SERVICE BULLETIN

model number 4240	bulletin number M-4240-A
for serial numbers Below 100001	
subject Elimination of AC Line Switching Transients	
engineering approval <i>E. Leggett</i> <i>(Signature)</i>	date 10-7-74

SCHEMATIC CHANGE

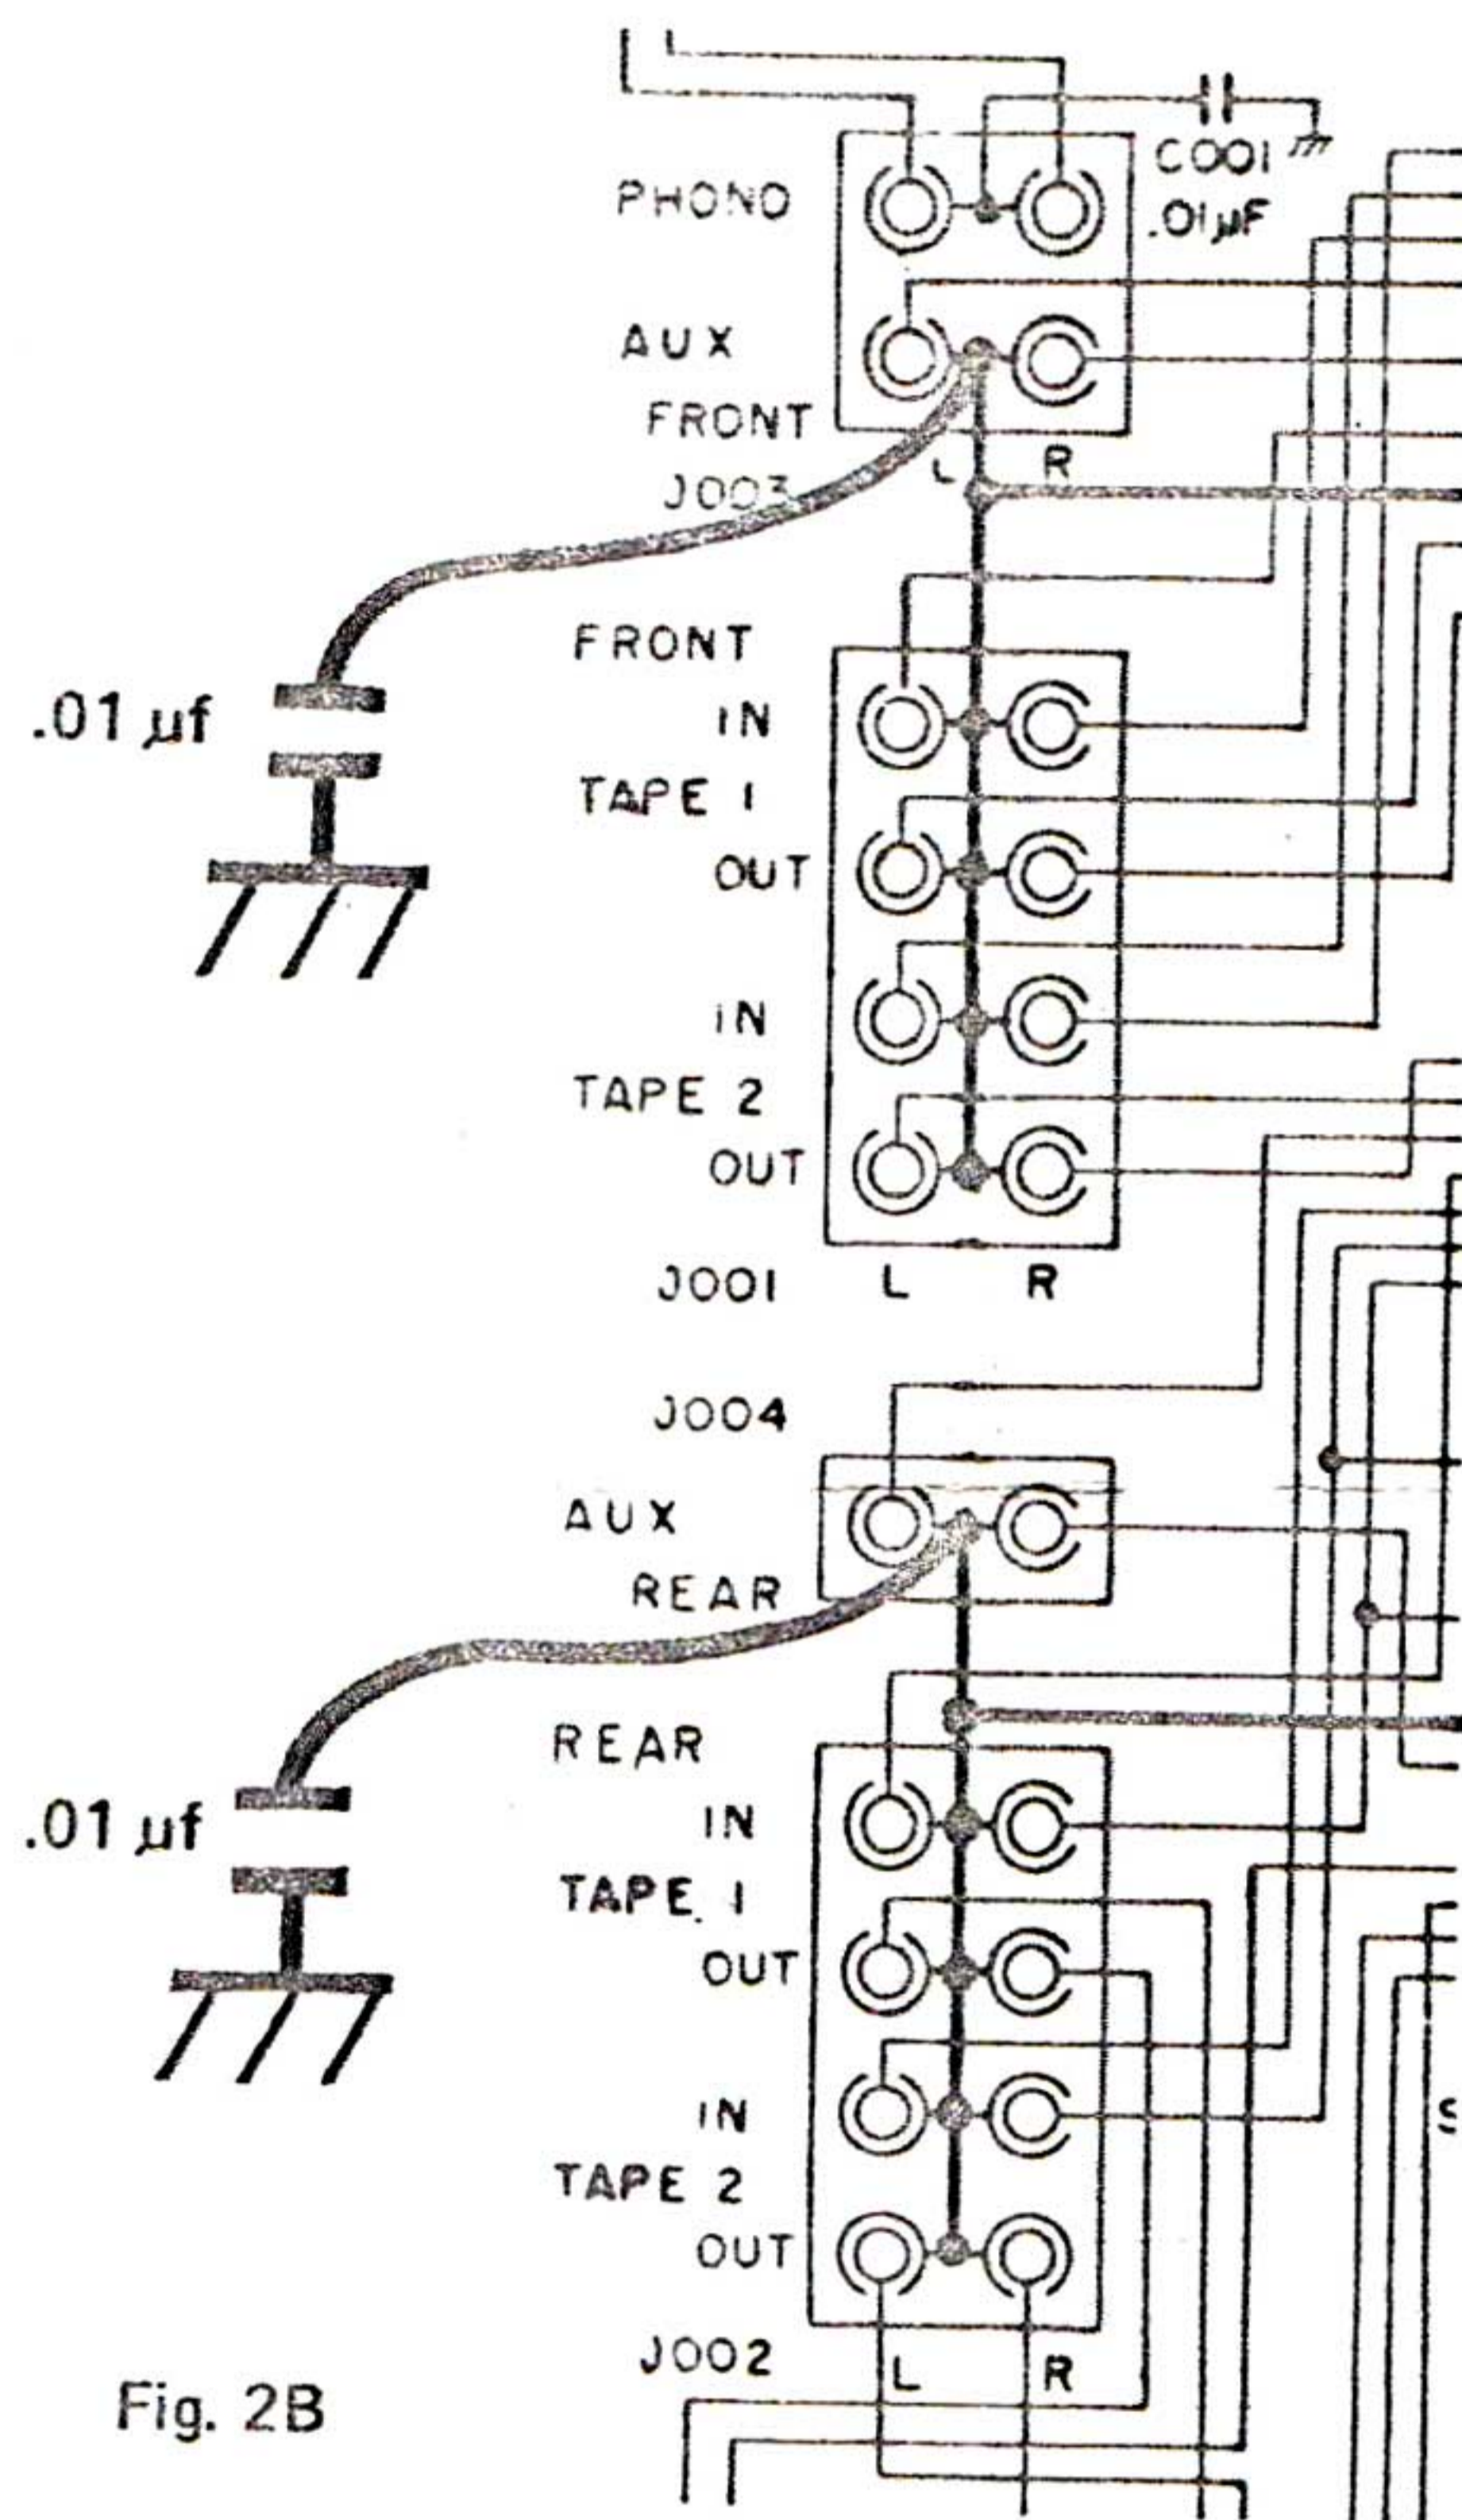
2. Connect a 0.01 μ F ceramic disc capacitor between chassis and common grounding bus of front channel AUX, TAPE IN and TAPE OUT jacks. Also, connect another .01 μ F capacitor between chassis and common grounding bus of rear channel AUX, TAPE IN and TAPE OUT jacks, (See Figures 2A and 2B).
